August 29, 2017

RE: OW-6 Groundwater Evaluation  
Evergreen Commons  
18 Boyd Dr and 5 Brown Avenue

FIGURE-2  
SUPPLEMENTAL GROUNDWATER  
ANALYSIS FIGURE  
DESIGN CONSULTANTS INC.  
AUGUST 23, 2017

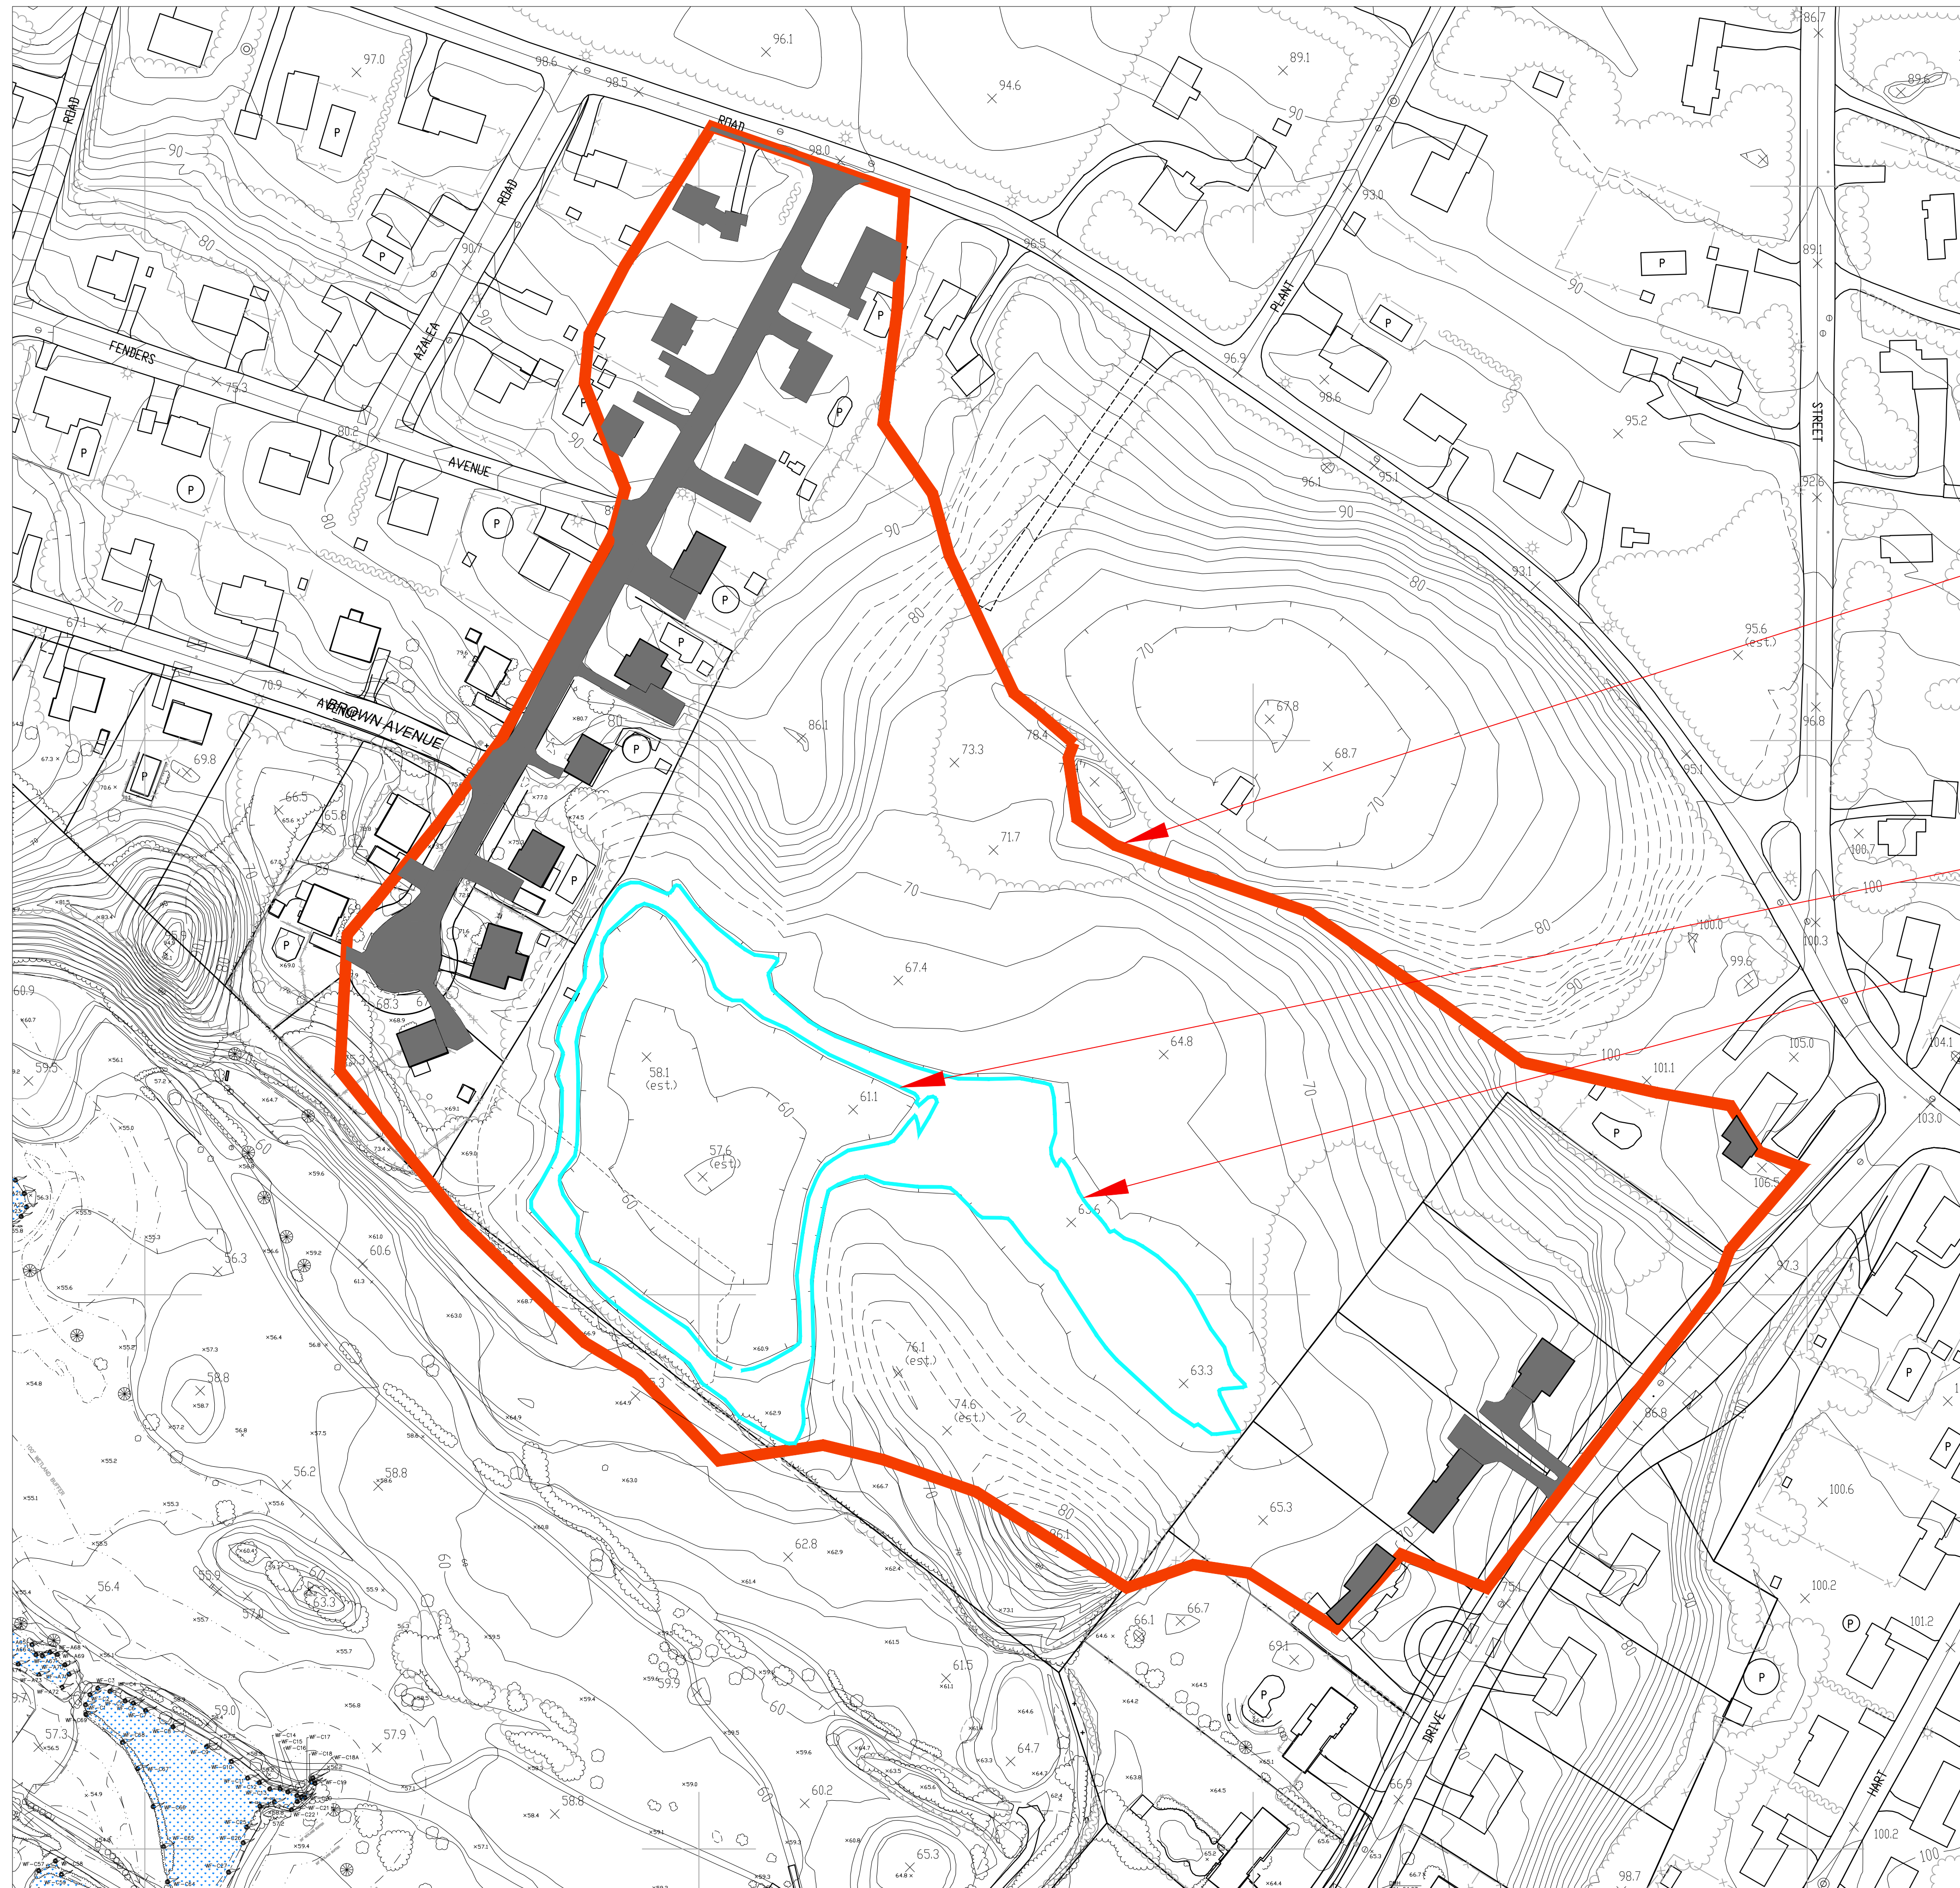
board peer review consultant on August 20, 2017, we see seasonal high groundwater elevations above that than the majority of the site where mottling indicates high groundwater at elevation 52(NAVD88). The soil mottles in the test pits along the property line adjacent to OW-6 indicate estimated seasonal high groundwater between elevation 54 and 55 (NAVD88). This elevation correlates with the historic reading from OW-6. See Figure 2 for this information. See Figure 2-Supplemental Groundwater Analysis and Figure 4 – Supplemental Boring Logs for this information.

3. The reason for the groundwater mound at this location is the fact that OW-6 lies with a separate isolated land subject to flooding (ILSF) area. There is a low area where untreated stormwater is directly discharged via a stormwater culvert from Briggs Avenue along with some of the homes on Boyd Drive both areas which are contributing drainage to the OW-6 ILSF. Based upon the ILSF calculation using a 7 inch rainfall event we see an ILSF elevation of 62.3(NAVD88) with the limit immediately adjacent to OW-6. We also calculated a 12 inch rainfall event, similar to that of the Mother's Day rainfall event and saw a flooding elevation of 63.8(NAVD88). Compounding this is the presence of a bedrock high under this area not allowing the water to readily seep back into the aquifer and limiting lateral flow. For these reasons OW-6 should not be used as an indicator of what should be used for groundwater levels found throughout the golf course aquifer. See Figure 2 – Supplemental Groundwater Analysis and Figure 3 – Briggs Ave ILSF Calculation.

4. Based upon information provided from the home owner of 16 Boyd Drive the groundwater was substantially below his basement elevation of 57.5(NGVD88). During the Mother's Day storm event there was extensive surface water running into and filling his basement. Upon recommendation from his neighbor located at 15 Boyd Drive, he drilled holes in the basement floor and the water immediately drained from the basement into the soil below. He experienced minor water in basement of the accessory building on the property to a maximum depth of 12 inches. The basement of this structure is at elevation 54.0(NAVD88). This would put the maximum water elevation of 55.0(NAVD88). It is not clear if this was caused by surface runoff or by a temporary increase in the groundwater elevation. We do know that once water was pumped form basement it did not fill back up and was dry on June 22, 2016 when the maximum groundwater elevation was taken in OW-6. See Figure 2-Supplemental Groundwater Analysis for this information.

NOTE 1.  
BASEMENT ELEVATION = 57.5  
DURING MOTHERS DAY STORM EVENT  
HOLES DRILLED IN BASEMENT FLOOR  
TO ALLOW SURFACE RUNOFF FLOWING  
INTO BASEMENT TO DRAIN. NO  
HISTORY OF GROUNDWATER IN  
BASEMENT.

NOTE 2.  
BASEMENT ELEVATION = 54.0  
DURING MOTHERS DAY STORM EVENT  
APROXIMATELY 12" MAXIMUM WATER IN  
BASEMENT. (POSSIBLE MAXIMUM  
GROUNDWATER ELEVATION OF 55.0±)

NOTE 3.  
BASED ON STANDARD ILSF CALCULATION  
7" RAIN EVENT. THE BRIGGS ILSF  
ELEVATION IS 6.7 FEET HIGHER THAN THE  
ILSF ELEVATION ON THE GOLF COURSE.  
THIS WOULD BE A MAJOR CONTRIBUTING  
FACTOR FOR OW-6 HIGH SPIKED  
READINGS AROUND EXTREME EVENTS.

NOTE 4.  
BASED ON PHOTOGRAPHS OF THE  
MOTHERS DAY STORM EVENT THE  
MAXIMUM WATER ELEVATION DURING THIS  
EVENT IS ESTIMATED AT 56.0±.

The current design provides for all basement elevations to be at or above 56.6(NAVD88). The closest foundation to OW-6 is 190 feet away with a proposed basement elevation of 58.95(NAVD88). Given the distance from OW-6 and the higher basement elevation at this location we are confident this basement is resilient even with a rain even of the magnitude of the Mother's Day rain event. Although we are confident the design provides for flood resiliency with an event such as the Mother's Day 2006, we are proposing to slightly adjust of the basements and roadway elevation on the project. We are proposing to lift the roadway by 6" which will allow the bio-retention areas to be lifted with the lowest bottom elevation to be at 55.2(NAVD88). This provides

a resiliency for even an extreme situation, keeping the bottom elevation above any potential groundwater spike during a storm event such as the 2006 Mother's Day event. Additionally, we are proposing to lift the lowest basement elevation to 57.5(NAVD88) or 11 inches above the current lowest proposed elevation. This small change provides an added factor of safety and resiliency for any potential future extreme events exceeding the 100 year storm event that is typically used at the extreme storm event in stormwater design. We are currently updating drawing to reflect this slight upward adjustment of proposed elevation and expect to be submitting the revised drawings within the week. We look forward to reviewing these changes at the September 20<sup>th</sup> Planning Board meeting. In the interim please feel free to contact me with questions.
